Applicant: Lectrosonics, Inc.
581 Laser Road
Rio Rancho, NM 87124

Re: Response to Correspondence reference number 31723

Equipment: FCC ID: DBZUM450L, 731-confirmation number EA177179

Photograph showing separation distance from the back of equipment to the antenna.

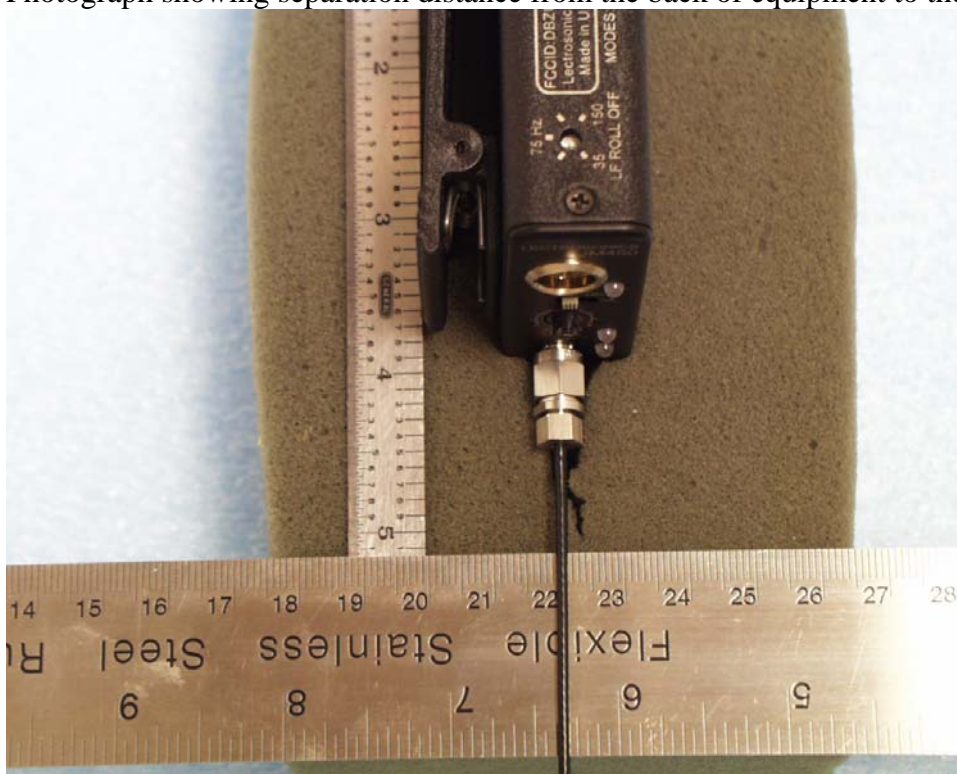
To support FCC RF exposure compliance determination, please submit photos and/or sketches for product with antenna installed showing spacings between the plane of the back of the belt-clip to: a) the back of the device, b) the closest point(s) of installed-antenna(s) FCC will then review all filing info to determine whether other info may need to be requested to support compliance with RF exposure requirements as applicable for all transmitters regulated by FCC. It may help to expedite this review if applicant has available and wishes to voluntarily submit SAR test results for this specific product

Below please find relevant photographs per your request demonstrating spacing between the back of the device and antenna, and the back of the clip and antenna.
